National Committee on Uniform Traffic Control Devices

TECHNICAL COMMITTEE: Temporary Traffic Control Technical Committee

TOPIC: Accommodating Bicyclists Through Temporary

Traffic Control Zones

Figure 6H-xx. Bicycle Lane Closure without Detour (TA-B1)

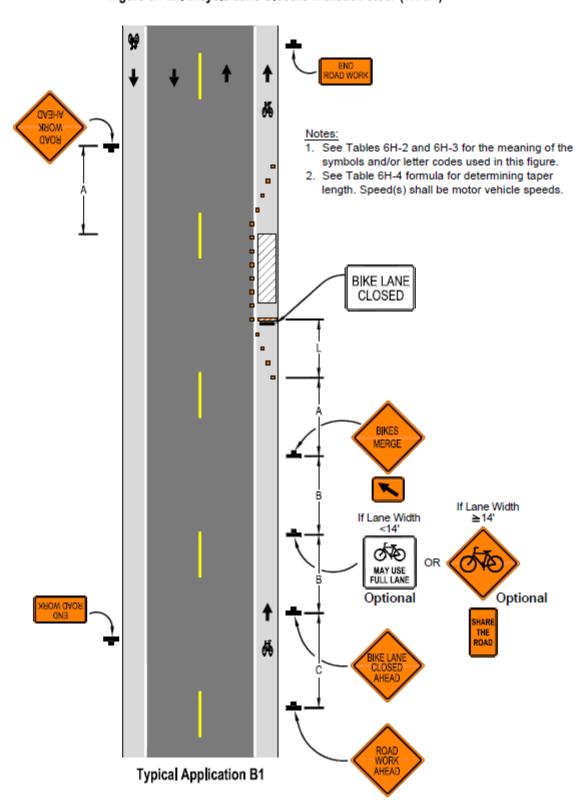
Notes for Figure 6H-xx – Typical Application B1 Bicycle Lane Closure without Detour

1. <u>If a bicycle lane on a roadway having a speed limit of 45 mph or higher is closed and conditions are not appropriate to direct bicyclists into a shared lane, a separate bicycle facility or detour route should be considered. Refer to TA-B2 or TA-B5.</u>

- 2. If a bicycle lane on a roadway having a speed limit of 40 mph or less is closed, and the adjacent travel lane is less than 14 feet wide, then Bicycles May Use Full Lane (R4-11) signs may be used.
- 3. If a bicycle lane on a roadway having a speed limit of 40 mph or less is closed, and the adjacent travel lane is at least 14 feet wide throughout the TTC zone, then Bicycle Warning (W11-1) signs in association with SHARE THE ROAD (W16-1) plaques may be used.

Figure 6H-xx. Bicycle Lane Closure with On-Road Detour (TA-B2)

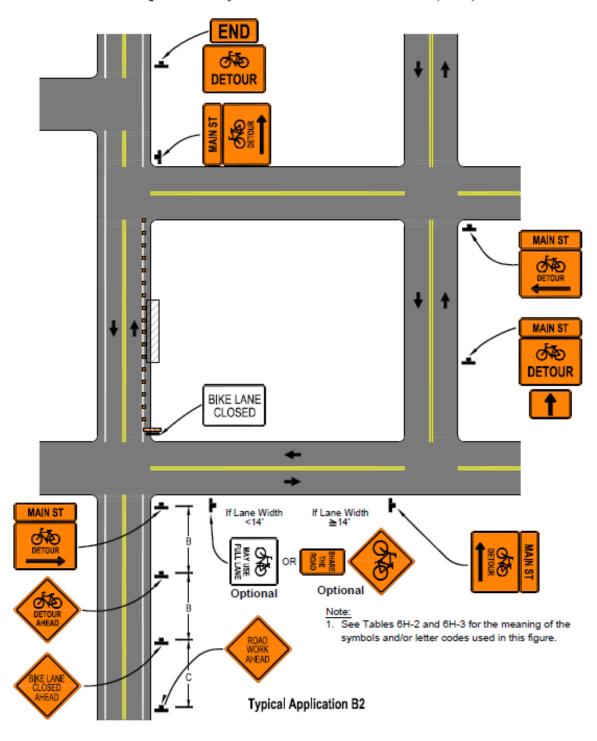
Notes for Figure 6H-xx – Typical Application B2 Bicycle Lane Closure with On-Road Detour

- 1. <u>A detour route for bicycle traffic where a section of bicycle lane is closed should use the most direct route practical on roadways where conditions</u> are appropriate <u>for bicycling</u>.
- 2. <u>Bicycle related regulatory and/or warning signs should be considered along the bicycle detour based on engineering judgment and traffic conditions.</u>
- 3. A Street Name sign or Bike Route Name sign should be mounted with the Bike Detour sign. The Street Name sign or Bike Route Name sign may be either white on green or black on orange.

4. Where used, the Street Name sign or Bike Route Name sign shall be placed above the Bike Detour sign.

Figure 6H-xx. Shared-Use Path Closure with a Diversion (TA-B3)

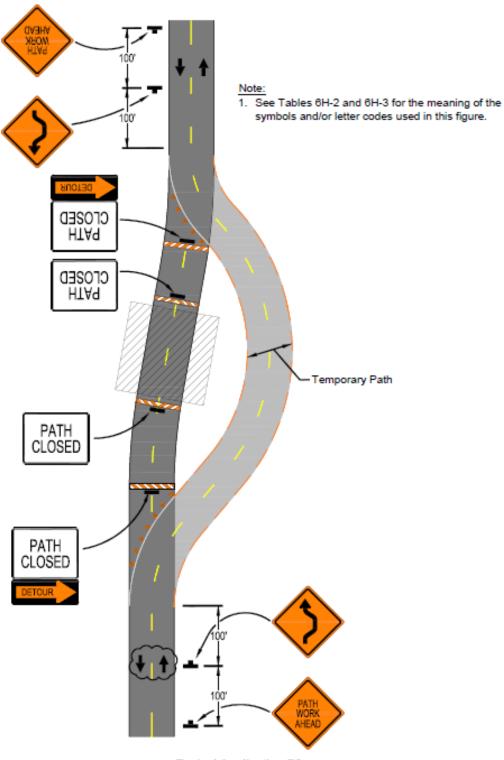
Notes for Figure 6H-xx – Typical Application B3 Shared-Use Path Closure with a Diversion

- 1. This plan should be used where a detour is provided for a shared-use path onto a temporary paved shared-use path.
- 2. The temporary paved shared-use path should be at least as wide as the shared-use path that was temporarily closed.

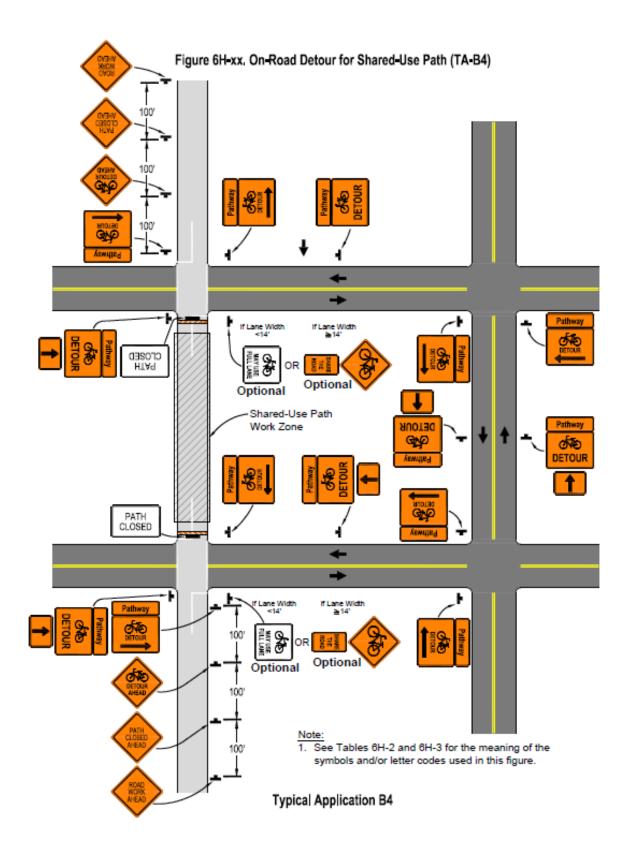
Notes for Figure 6H-xx – Typical Application B4 On-Road Detour for Shared-Use Path

- 1. This plan should be used where an on-road detour is provided for bicycle traffic using a shared-use path.
- 2. The on-road detour route for bicycle traffic should use the most direct route practical on roadways where conditions are appropriate for bicycling.
- 3. <u>Bicycle related regulatory and/or warning signs should be considered along the</u> bicycle detour based on engineering judgment and traffic conditions.
- 4. <u>A Street Name sign or Bike Route Name sign should be mounted with the Bike Detour sign. The Street Name sign or Bike Route Name sign may be either white on green or black on orange.</u>

5. Where used the Street Name sign or Bike Route Name sign shall be placed above the Bike Detour sign.
